Addendum #1

Camp Keyes Training Site Telecom Room Upgrades, Augusta, Maine
Project No. 23SC19-314-D, Bid Number 20-035

Directorate of Facilities Engineering

20 May 2020

SHEET ID:
DFE-03
SHEET: 3 OF 3

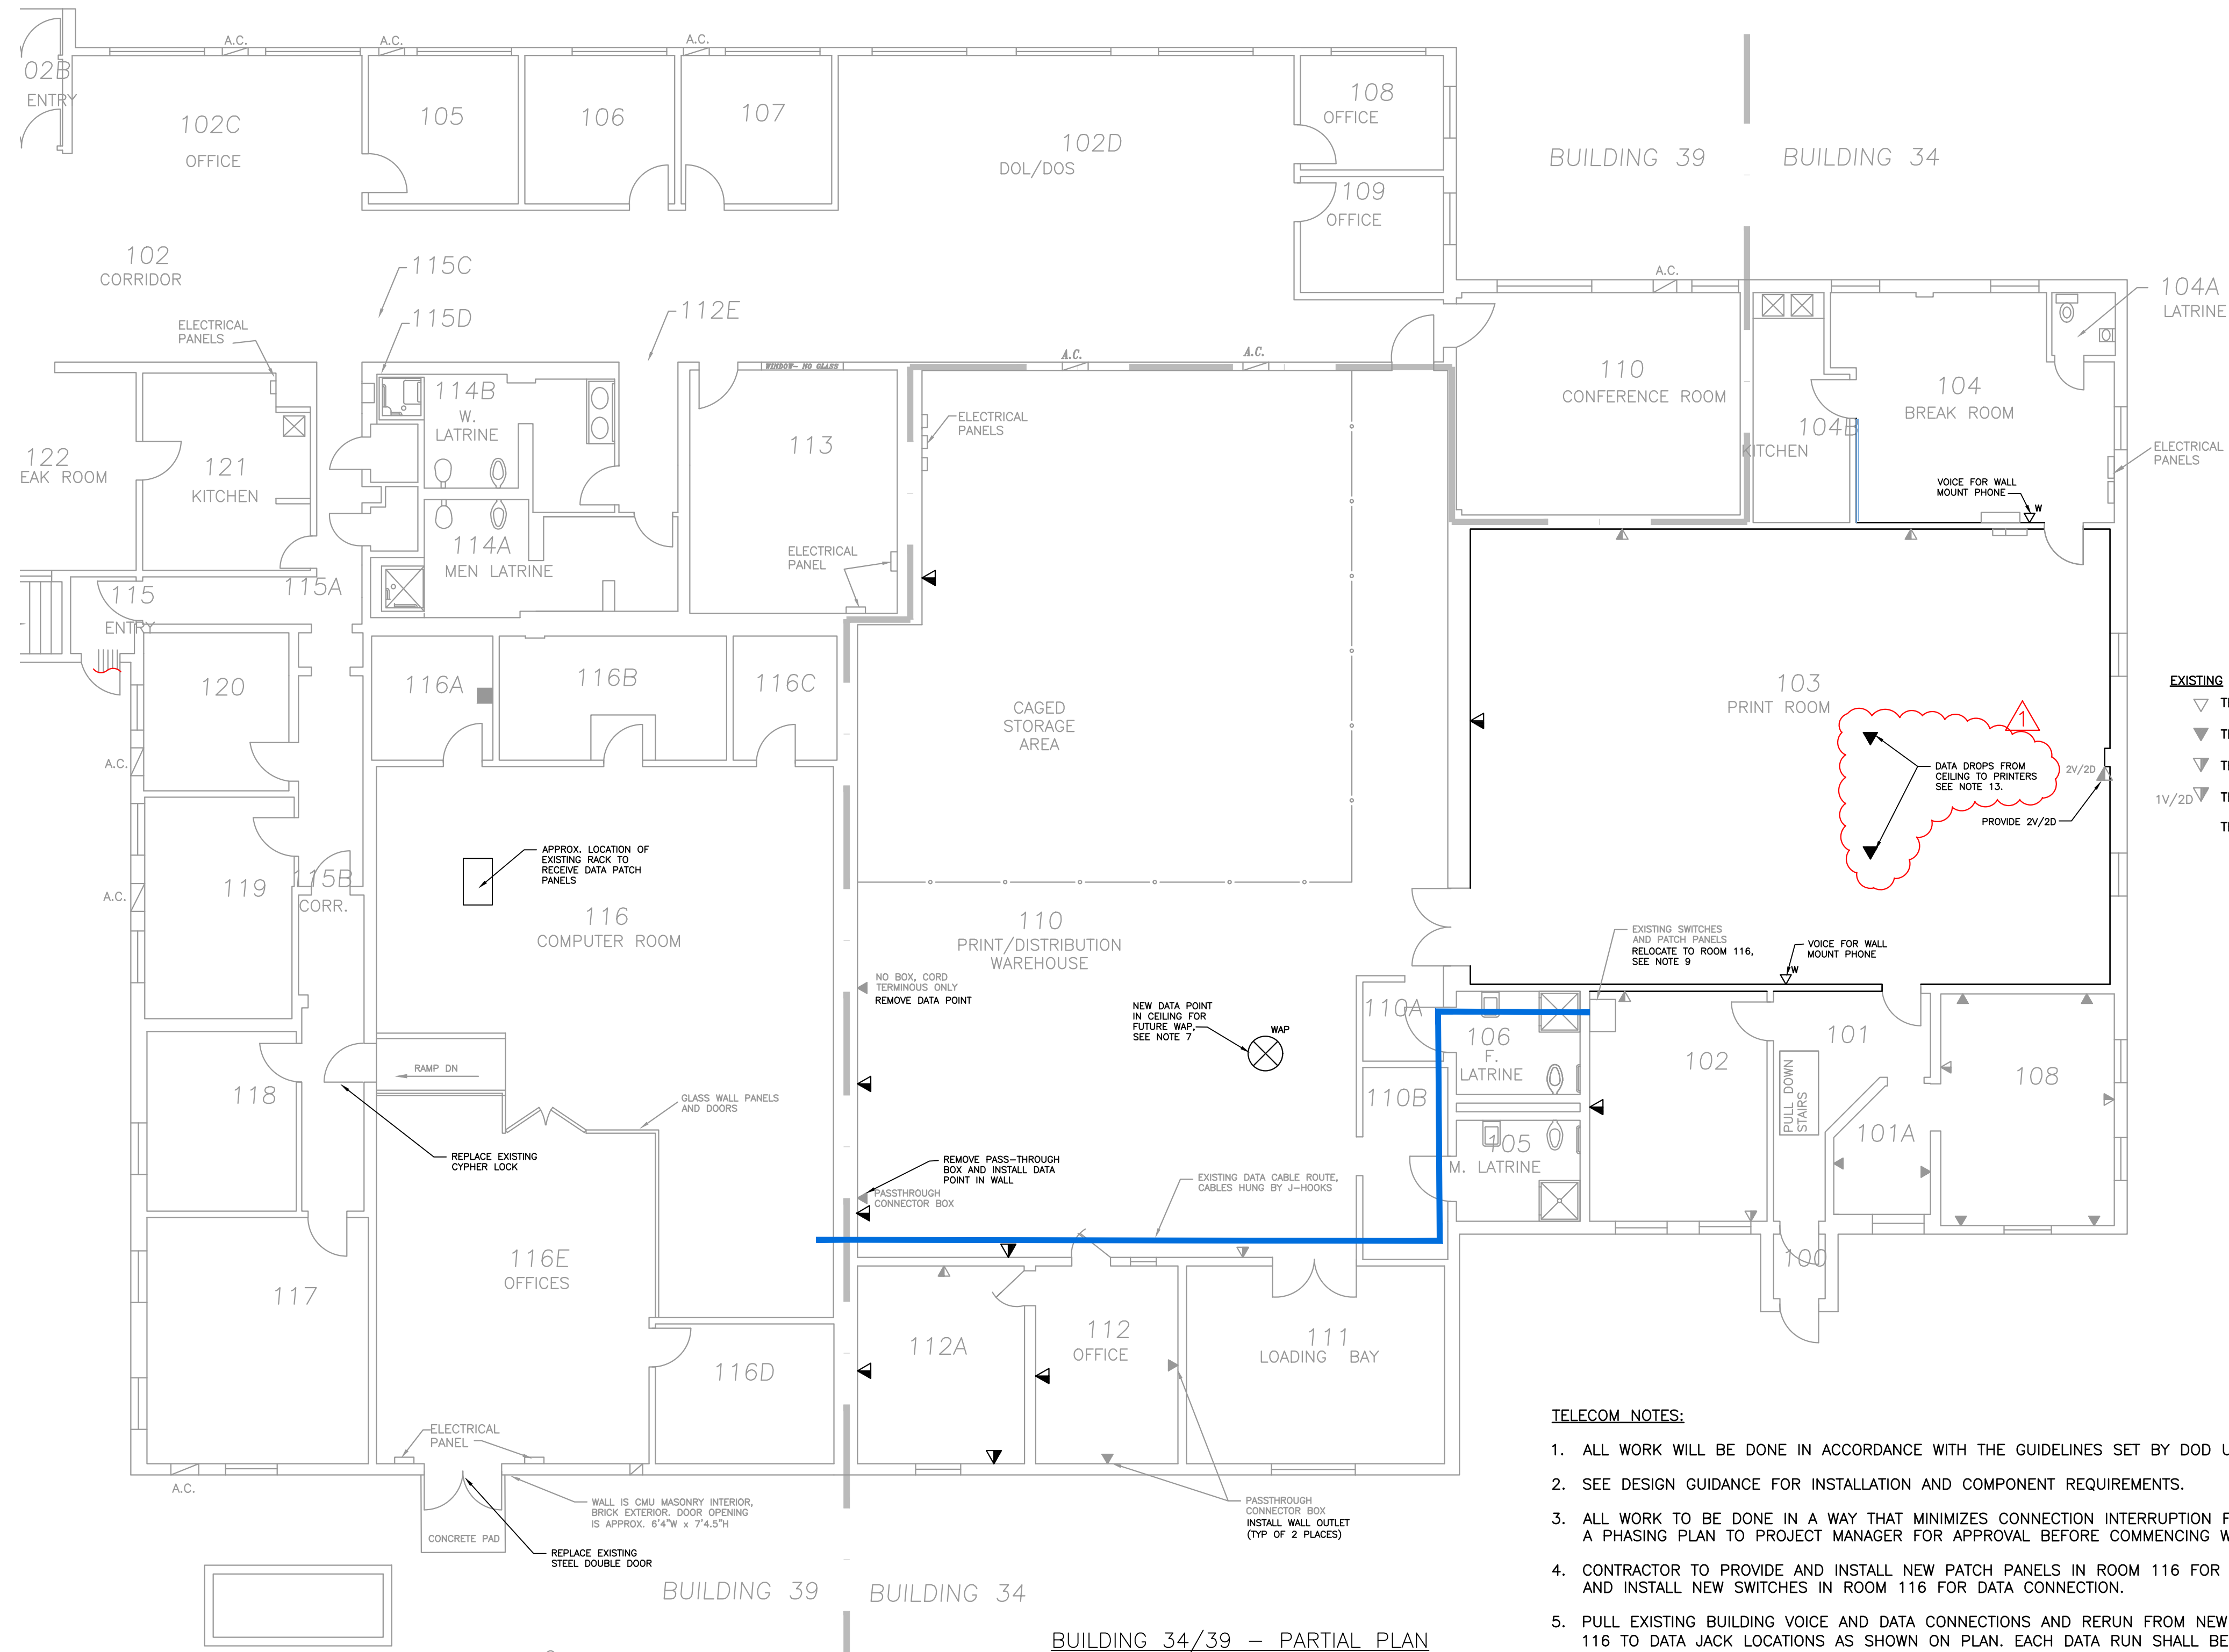
1. Sheet DFE-03: Addition of notes for data drops in Room 103
 - a. Remove drawing and replace with attached updated drawing.

Q: The plans show 2 existing data drops in the ceiling of Room 103. Are those proposed or existing to be replaced?

A: The plans show existing data drops to be rerun which is incorrect. The drawings will be revised and an Addendum sent to you after the Questions deadline on May 18. Until then:

- PROVIDE 2 NEW DATA DROPS FROM CEILING. FIELD LOCATE WITH OWNER OVER EQUIPMENT. PROPOSED DATA PORTS SHALL BE TWO SINGLE CAT 6 DATA DROPS, EACH SHALL BE PROVIDED WITH CABLE LONG ENOUGH TO REACH THE FLOOR FROM THE FACEPLATE IN ADDITION TO MAINTAINING 10' SLACK CABLE COILED ABOVE THE CEILING. THE CEILING MOUNTED FACEPLATE SHALL HAVE A CABLE PASS THROUGH WITH A CABLE RESTRICTOR MADE OF BRUSHES.

The proposed data ports will be two single CAT 6 data drops from the ceiling in separate locations as shown on plans. Each will be provided with cable long enough to reach the floor from the faceplate in addition to maintaining 10' slack cable coiled above the ceiling. The ceiling mounted faceplate shall have a cable pass through restrictor made of brushes.
